SERVICE BULLETIN

<u>ENGINE - LP COMPRESSOR - THREAD CHANGE OF FAIRING REAR ATTACHING BOLT - CATEGORY CODE</u> <u>6 - MOD.ENG-72-0219</u>

V2500-ENG-72-0219

Before and After Alteration of Socket Head Bolt Fig.1

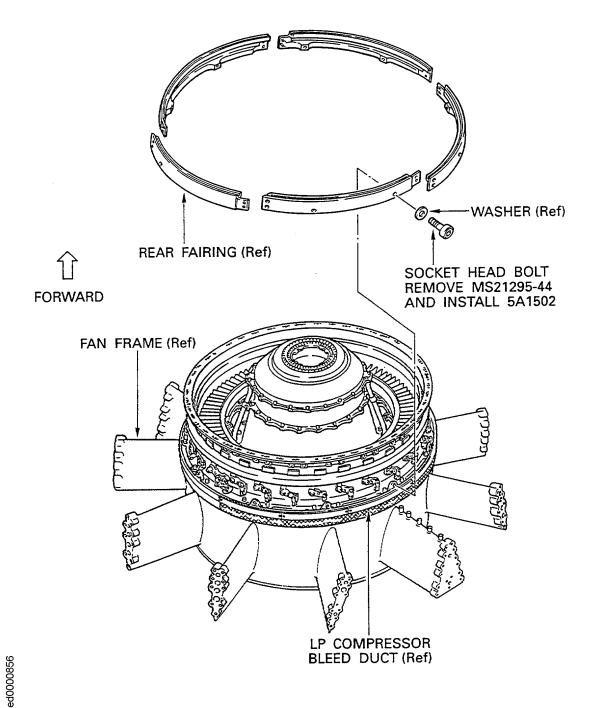
Damage to the threads of the bolts used to secure the rear fairing to the LP Compressor bleed duct has occured in service.

It was determined that the thread of the existing bolts was incompatible with the theads of the mating bleed duct.

The change recommended in this Service Bulletin is intended to prevent damage on the thread of bolt.

- (1) This bulletin introduces a bolt with the proper thread specification. See Figure 1.
- (2) For relationship with other Service Bulletin, see 1.L. References.

Install the 5A1502, Socket Head Bolt by the approved Engine Manual, Chapter/Section 72-32-00, Assembly-12, Config-2.
